Your ref: 24/00494/FUL

Drummarnock Wind Farm - SEPA Response

Drummarnock Wind Farm

Figure 1-5
T3 Constraints

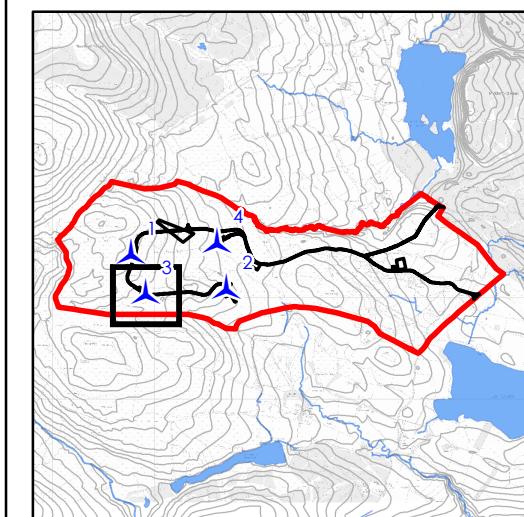
SEPA has advised that: “*Should there be no constraints, we would ask whether turbine 3 could be relocated to the opposite site of the track where there appears to be less peat*”.

The Applicant has carefully considered the location of Turbine 3 (T3) through a detailed constraints analysis. Turbine 3 is currently located on peat between 0.5–1 m depth, with most infrastructure on the southern side of the track and the blade/nacelle storage area on the northern side.

The location of Turbine 3 has been carefully sited to minimise environmental impacts upon many factors including landscape and visual, cultural heritage, potential encroachment towards watercourses, peat and highly dependent GWDTE’s. Turbine 3 has also been sited carefully to avoid infrastructure in the form of the point-to-point fixed telecommunications link to the southwest (Ref. 1082233/2).. Further detail can be found within the 2024 EIA Report and changes to the design are highlighted within the Additional Information Report.

These constraints are illustrated in Figure 1-5: T3 Constraints (Appendix A).

Relocating the turbine north to the other side of the track would encroach upon a 50 m watercourse buffer and cause direct and indirect loss of highly dependent M6d GWDTE habitat in the elongated valley bottom to the north. Moving northwest would place the turbine on peat up to 2 m deep, offering little or no benefit in reducing deep peat impact. Therefore, relocating Turbine 3 would not optimise the avoidance of these constraints.

Mitigation is already proposed for the down-gradient, highly dependent M6 GWDTE located north of Turbine 3. This includes cross drains under tracks at regular intervals, with subsurface drainage directed to a suitable diffuse outfall above the GWDTE, avoiding indirect loss. The 0.5–1 m depth peat excavated will be reused locally.

- Avoid – Attempts to avoid impact on peat through the siting of the turbine to the north of its final location was investigated and ultimately ruled out due to the potential for impacts on highly dependent GWDTE. Movement north was also prevented by the telecommunications link.
- Minimise – Impacts on peatland was minimised by orienting the hardstanding of the turbine so as much would be located outwith the peat deposits as possible.
- Restore – Extensive restoration is proposed as detailed in the Additional Information Report and its Technical Appendix 3: Habitat Management Plan.
- Enhance - Extensive enhancement is proposed as detailed in the Additional Information Report and its Technical Appendix 3: Habitat Management Plan.

The current location of Turbine 3 has been designed to minimise environmental impacts and is considered appropriate and compliant with guidance. Any movement of Turbine 3 is anticipated to result in greater environmental impacts due to other constraints on Site
